**Des Moines General
Osteopathic
Hospital**

RE: NRC License No. 14-18626-02

In response to your cover letter dated February 26, 1985 we propose the following:

Plan #1

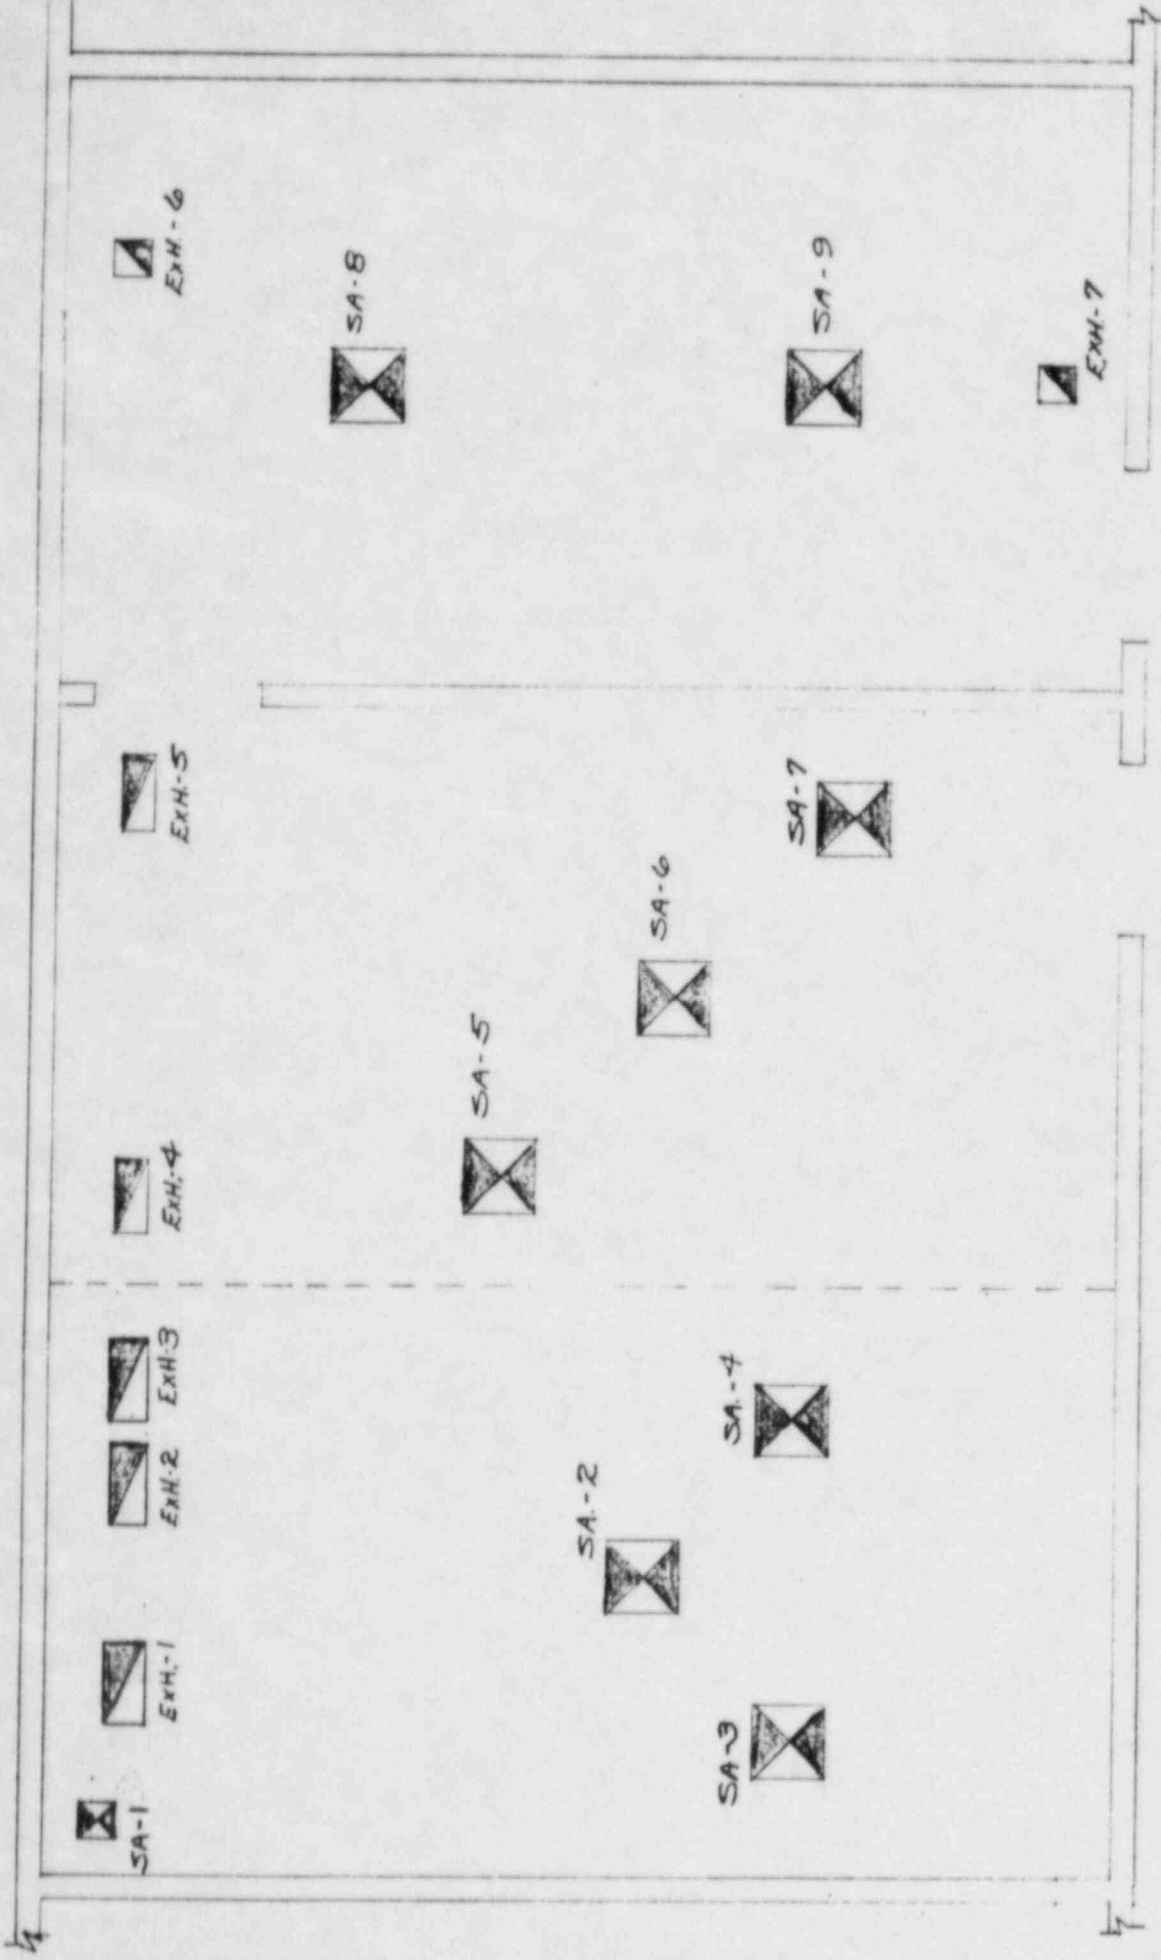
Item I: The air supply and exhaust rates have been changed to meet your regulations (see enclosure #1). Des Moines General Hospital will check flow rates every six months using standard protocol and will record to assure a 10% differential for negative pressure.
